CREEKSIDE SOUTH AT LORSON RANCH FILING 1

Final Plat SF-20-XXX

Summary of Comments on Microsoft Word - Creekside South Final Plat Letter of Intent.6.22.2020

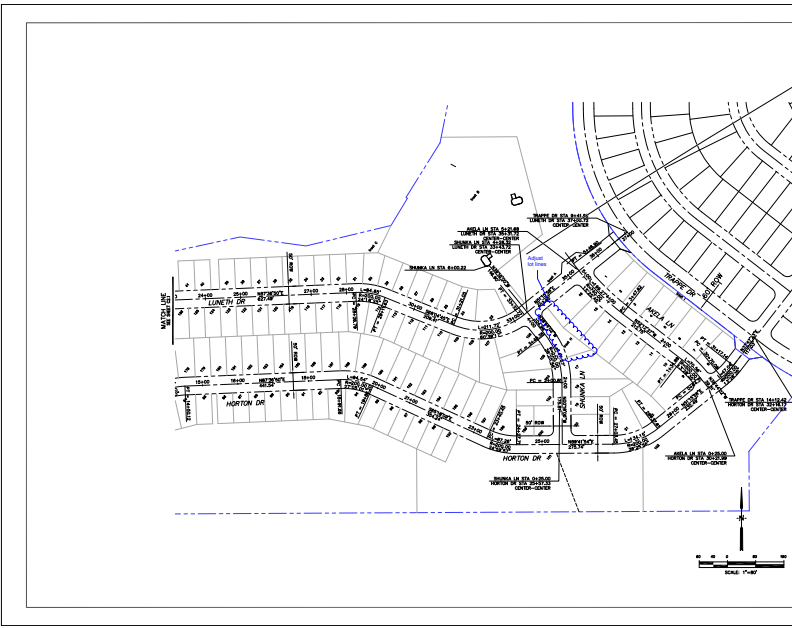
Adjust for lines

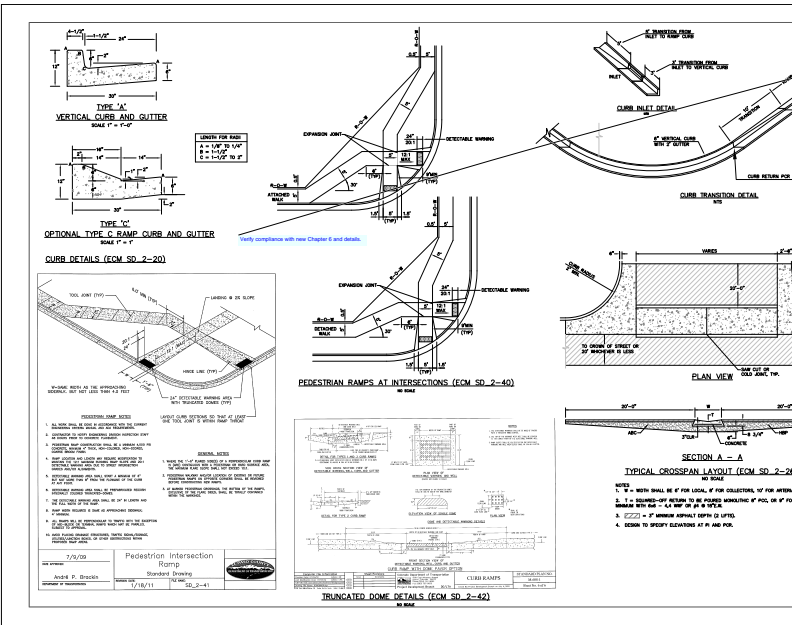
Adjust to meet ADA requirements.

Adjust to meet ADA requirements 2.00%

Adjust to meet ADA requirements
